PRELIMINARY/FINAL DRAINAGE REPORT

MIDTOWN COLLECTION AT HANNAH RIDGE
FILING No. 3
(A Replat of Tract CC, Hannah Ridge at
Feathergrass Subdivision Filing No. 1)
PUDSP-20-007

DECEMBER 2021

REFERENCE MATERIAL FROM ADJACENT STUDIES
EXISTING CONDITIONS DRAINAGE MAP

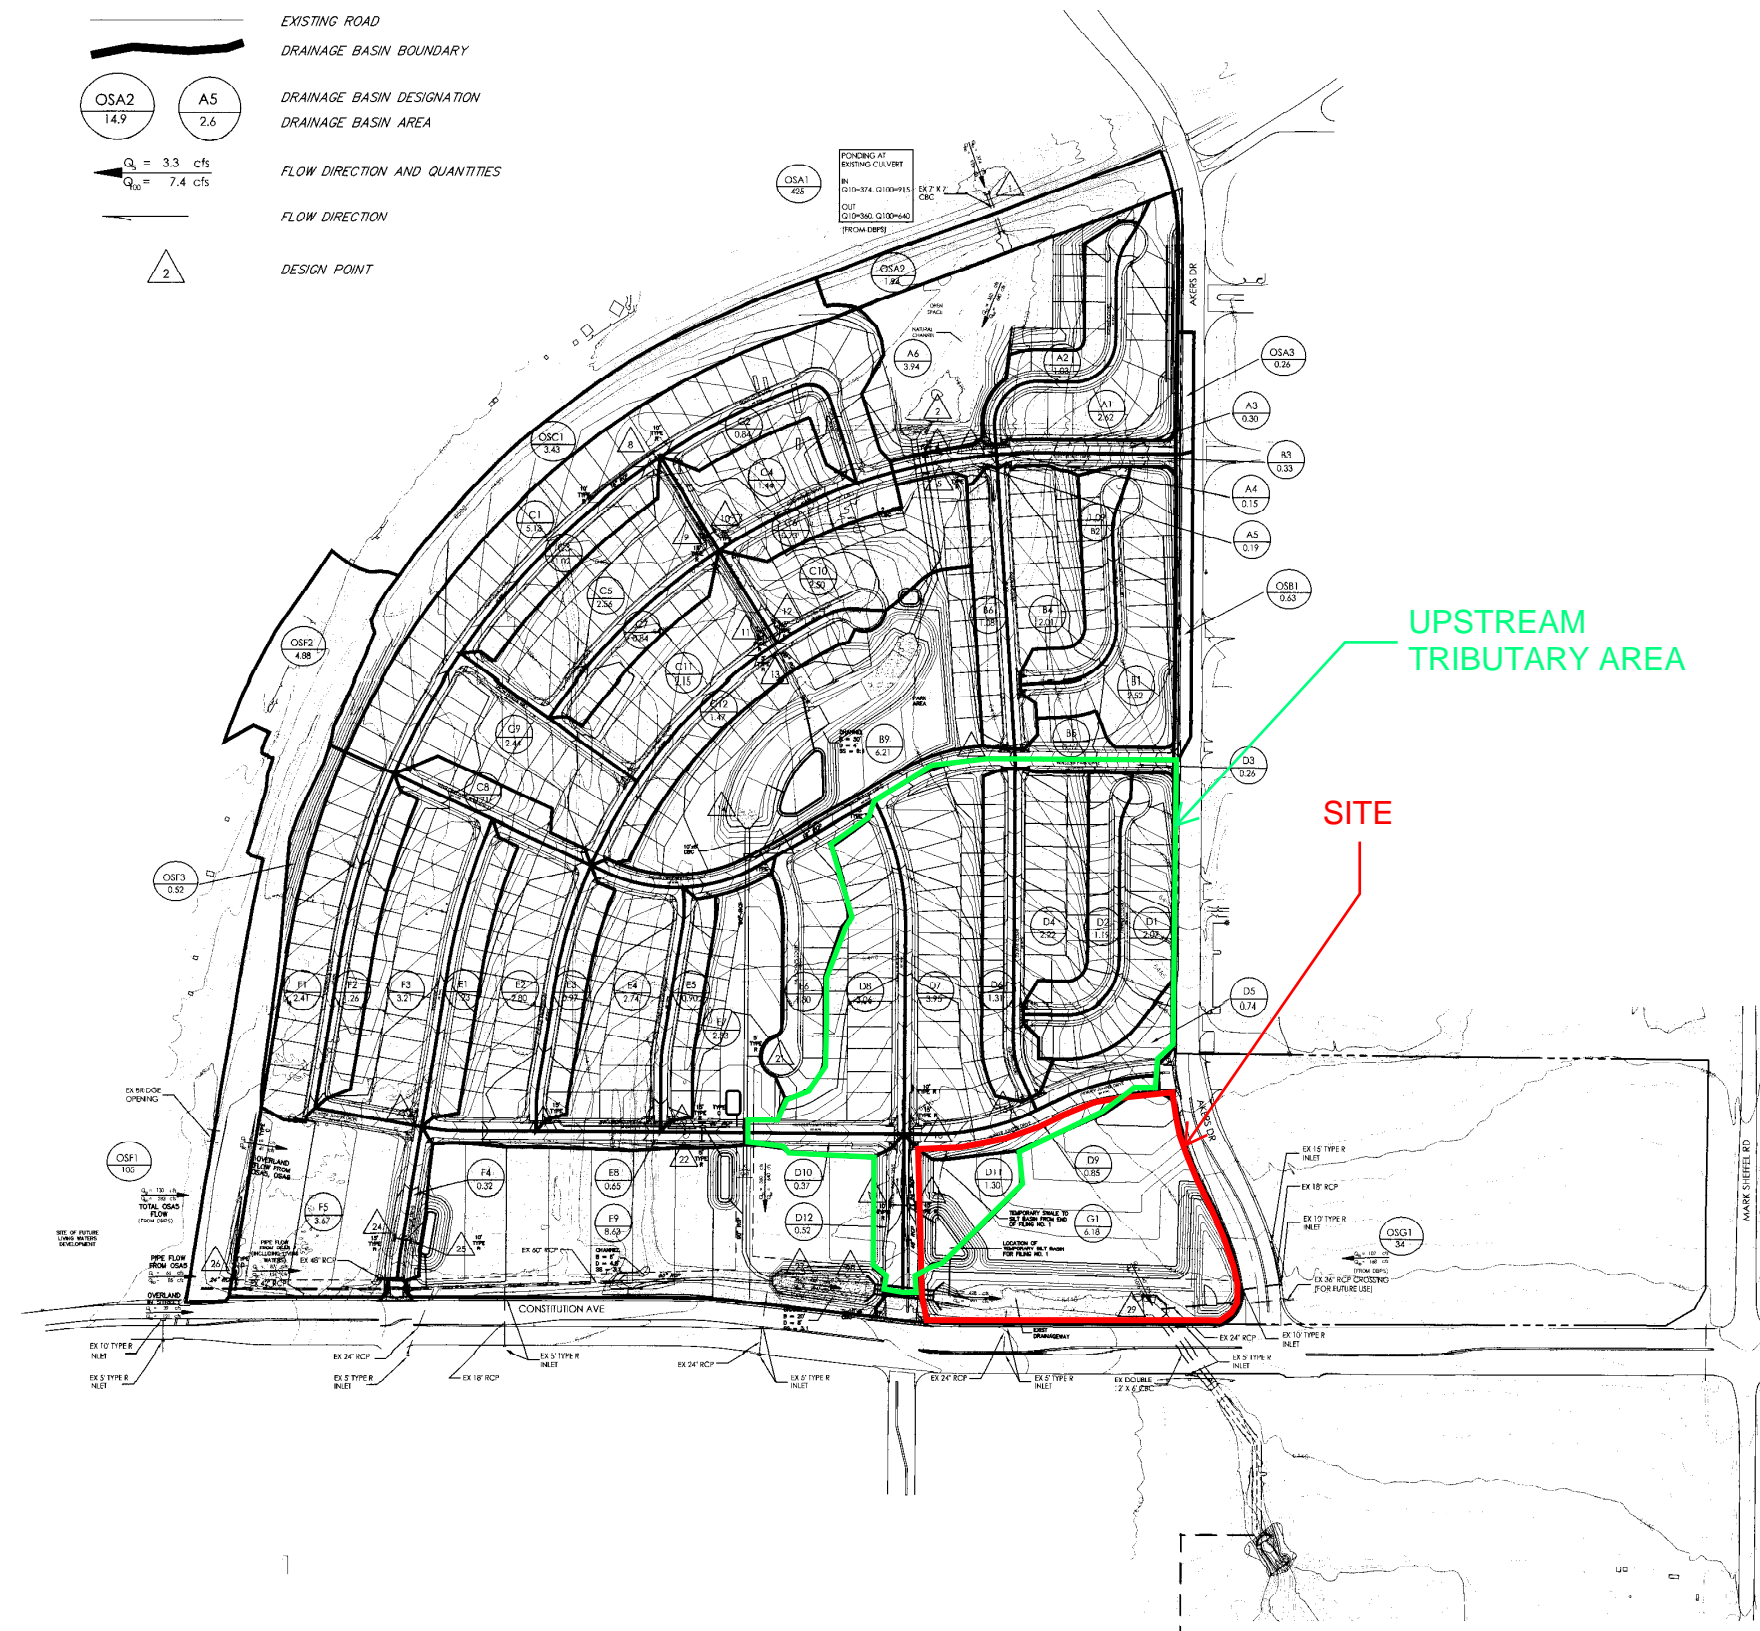
Include copies of calculation sheets that accompanied this map from previous report.

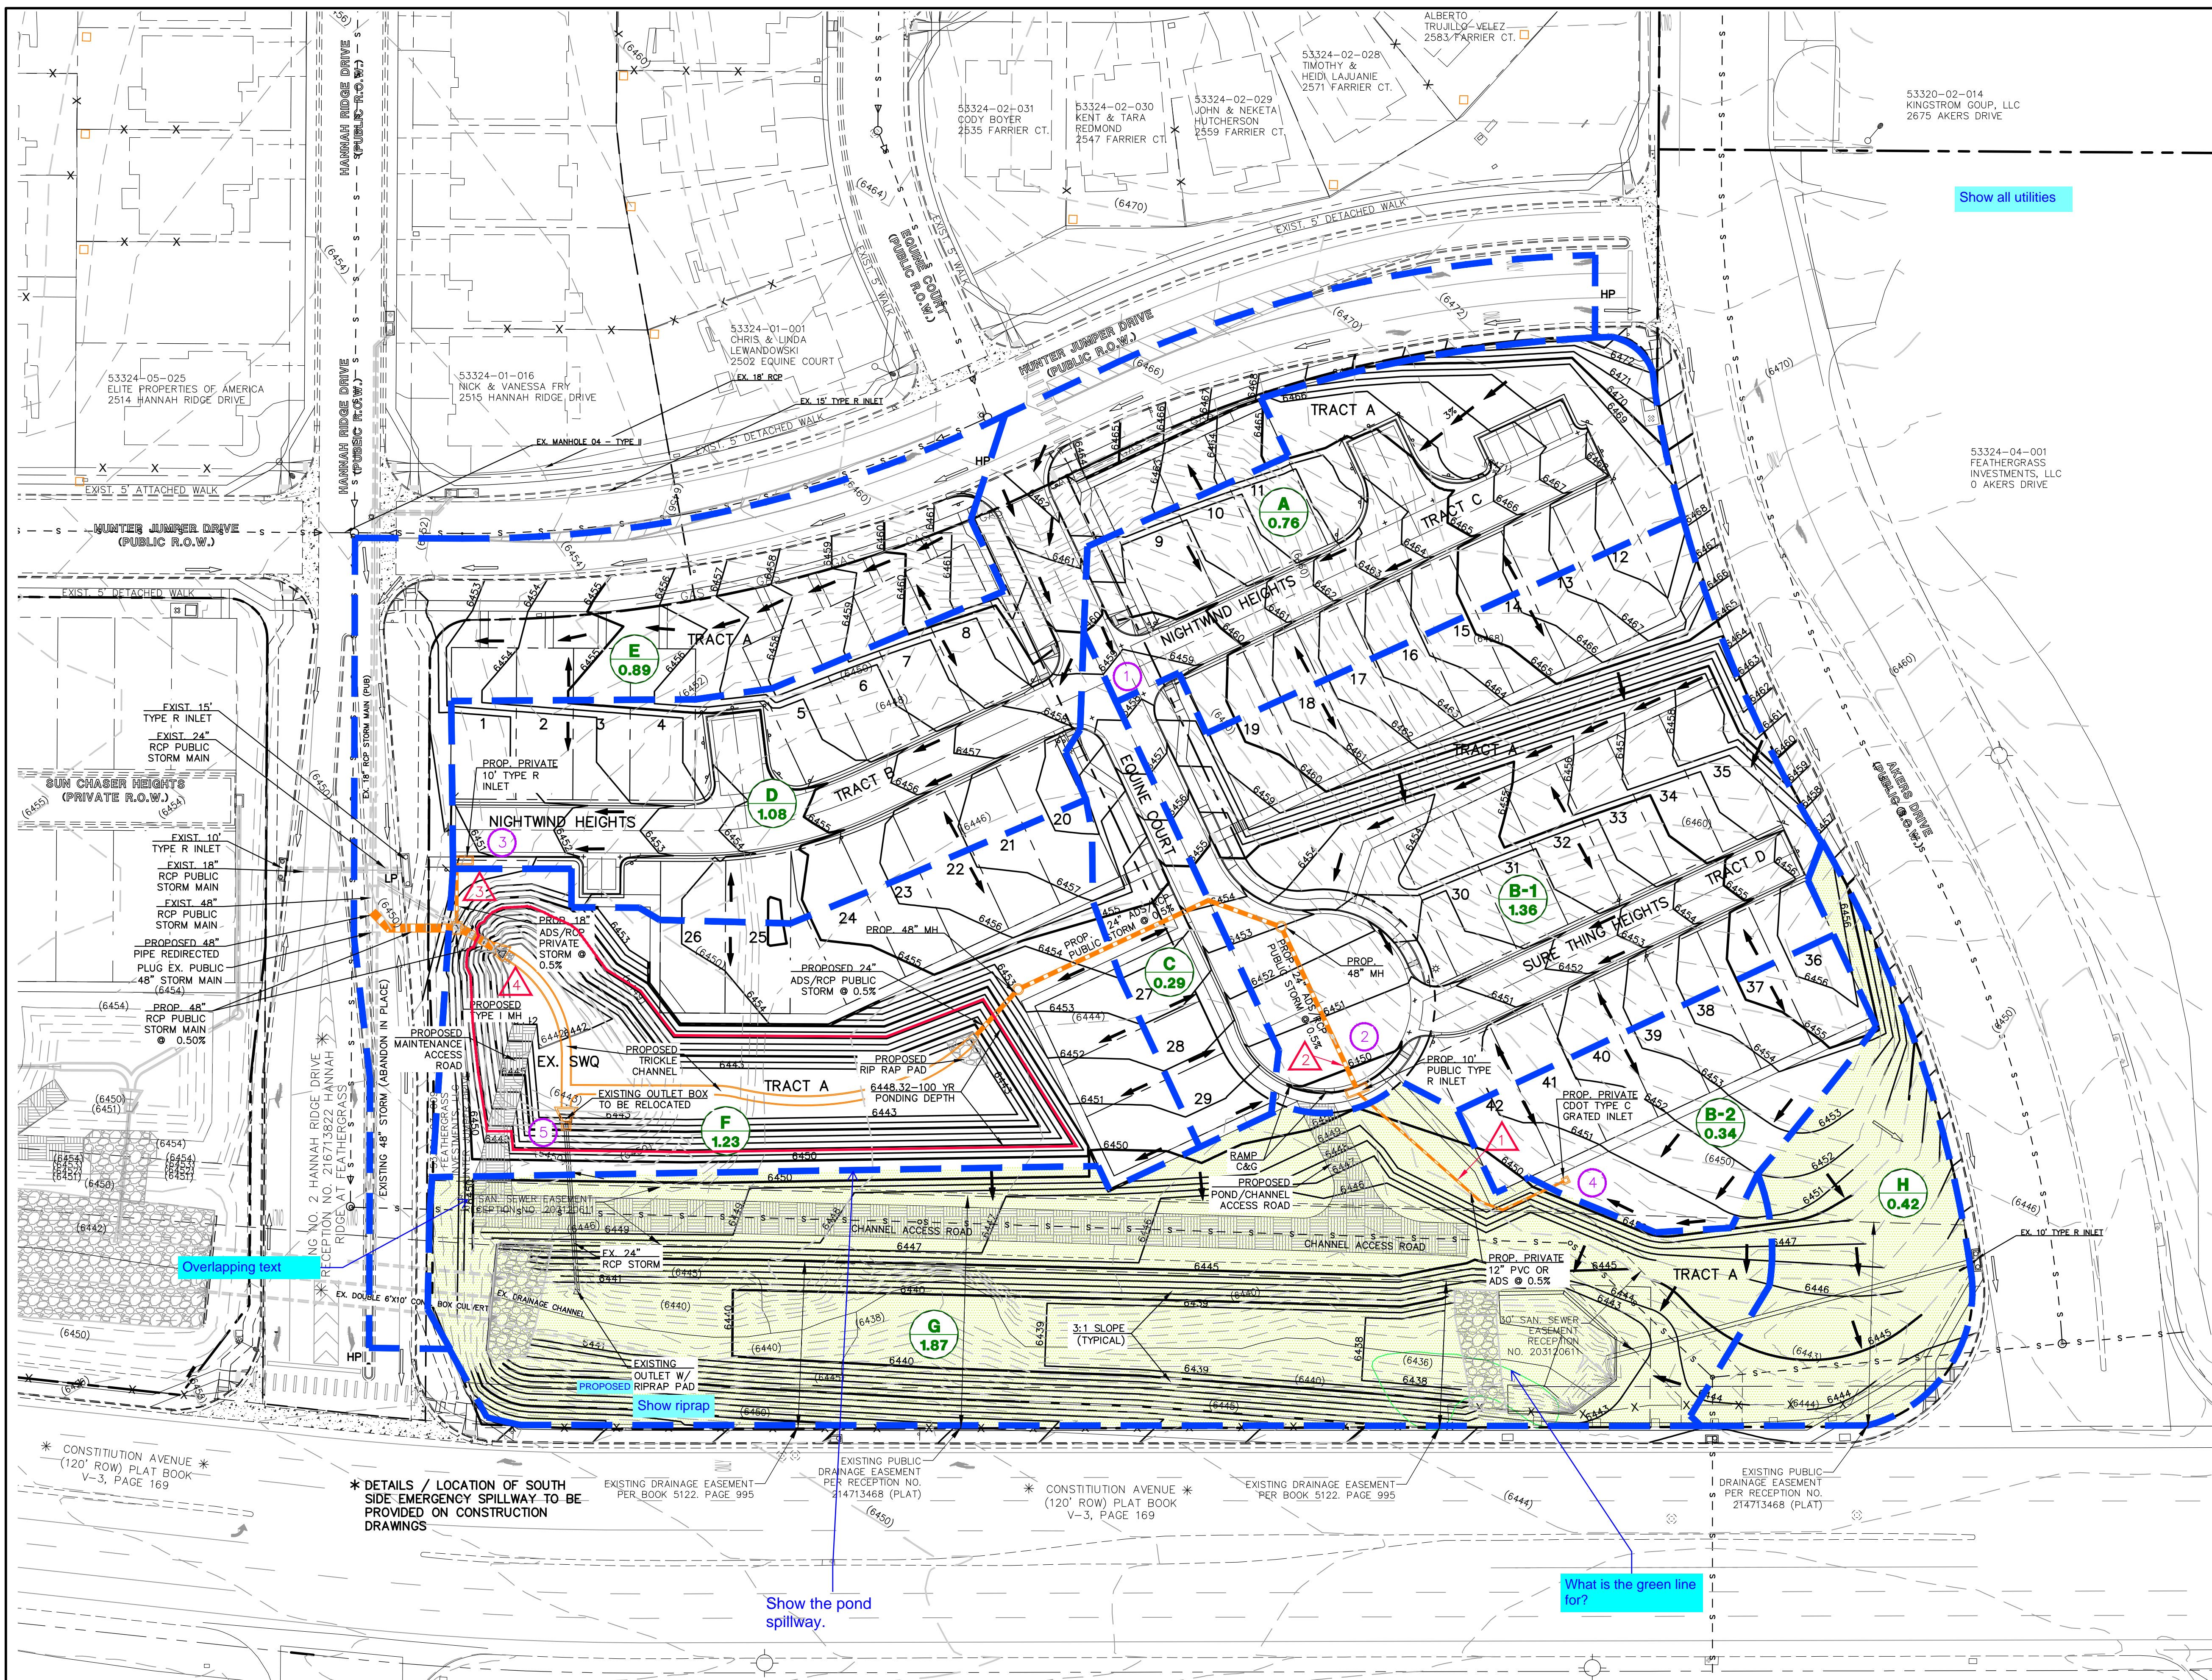
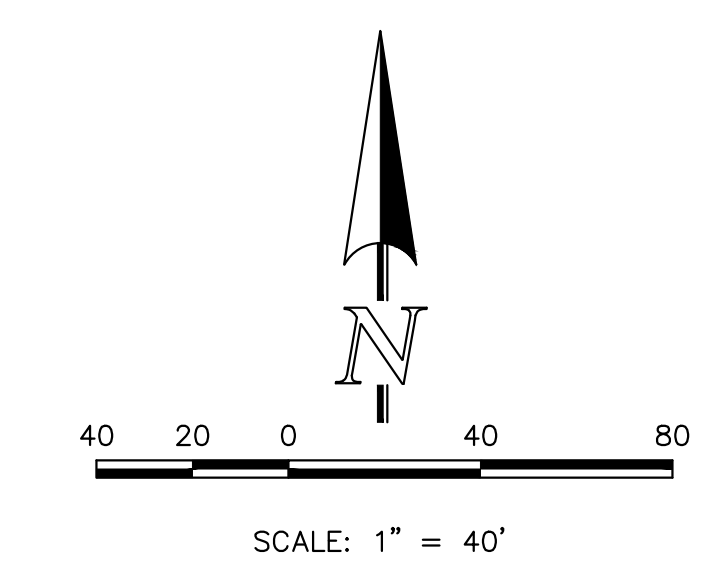
Provide Existing or overall Drainage Plan showing the entire drainage area to the FSD. This can be combined with the MS4 map requested in the comments.

Show all utilities

Show riprap

Show the pond spillway.
